**SUBJECT:** COMANCHE PEAK STEAM ELECTRIC STATION (CPSES)  
DOCKET NOS. 50-445 AND 50-446  
REQUEST FOR ADDITIONAL INFORMATION REGARDING  
LICENSE AMENDMENT REQUEST (LAR) 01-012  
STEAM GENERATOR TUBE REPAIR USING LEAK TIGHT  
SLEEVES

## Response to NRC Questions Concerning Hydraulic Equivalency for Leak-Tight Sleeves

Figure 3-1 Ratios of Hydraulic Equivalencies Based on the Test Data to SLEEVE Code Predictions

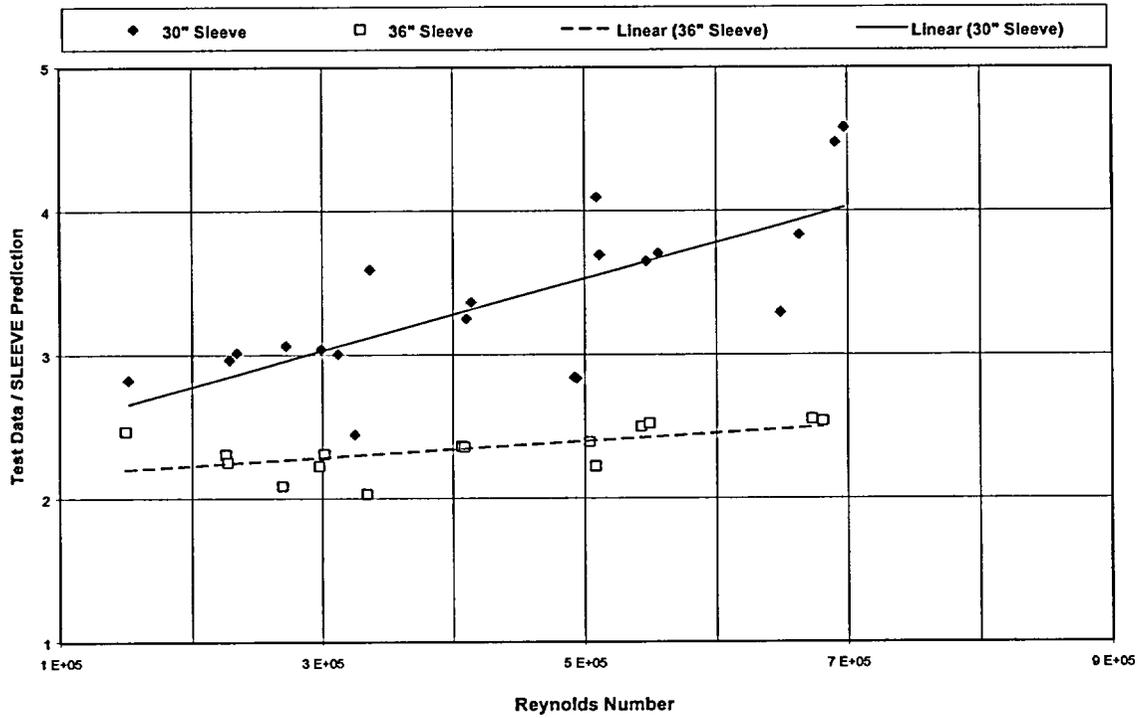
3. We do not recall any mention of an expansion/contraction multiplier to account for transitions that were gradual as opposed to sharp in the laser modeling. Were such multipliers used? If so, what values were used? The same observation and question applies to the test configuration. How do the coefficients compare with those from a traditional reference such as Crane Technical Paper 410?

conservative to use a sudden contraction or sudden expansion for both the laser sleeves and its test configuration in calculating the hydraulic equivalency. As demonstrated from comparison between the calculations and tests, the conservatism is at least amounted to a factor of 2; in fact, could be as high as 4 (see Figure 3-1).

As shown, the ratios of the hydraulic equivalency numbers range only from 1.3 to 1.5. It is apparent that use of sudden transitions to replace the actual gradual transitions doesn't account for the total conservatism of 2 to 4 times, as demonstrated by test results (see Figure 3-1). In other words, it seems to indicate that there are still other conservatisms in the calculation by the Westinghouse SLEEVE Code.

Both the laser sleeves and the test configuration evaluated the sudden transitions, not the gradual ones. Therefore, no multipliers were used in both situations. Thus, their comparison with the Crane Paper 410 is similar to the table shown in response to question 1 for the sudden contraction. As for the sudden expansion, they are exactly identical to the Crane Paper 410, because they all use the same correlation (see Equation (2-5) shown in response to question 2).
